Product Specification:
Valve Tag - Brass

Shop Drawing Submittal Review

Project Name: Webster University-**ISB**

PROJECT NAME:	Webster University ISB
LOCATION:	St. Louis Missouri
CLIENT PROJ. NO.:	N/A
WES PROJ. NO.:	607
SPECIFICATION SECTION:	220553 Identification for Plumbing Piping and Equipment
SUBMITTAL ITEM:	See Below -

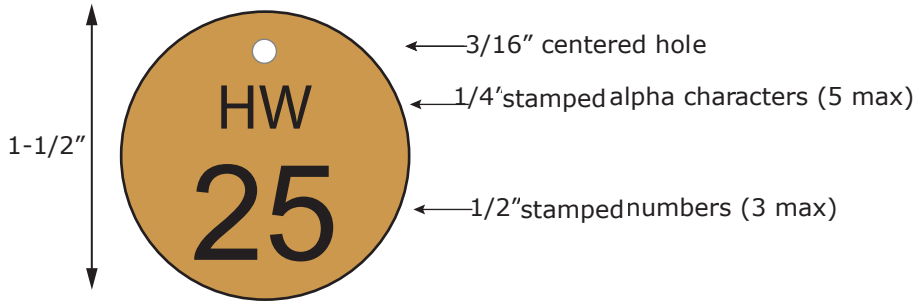
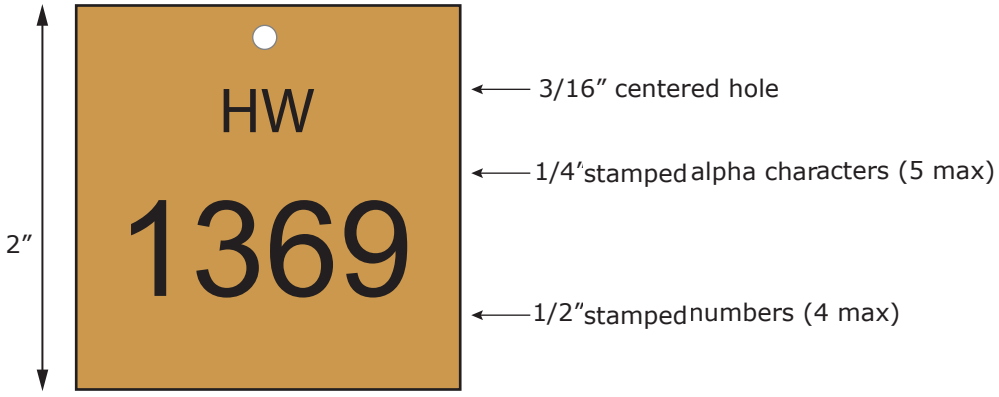
Specified to be aluminum, Refer to specification section 220553, Part 2, Paragraph 2.4, line B1. Brass is acceptable.
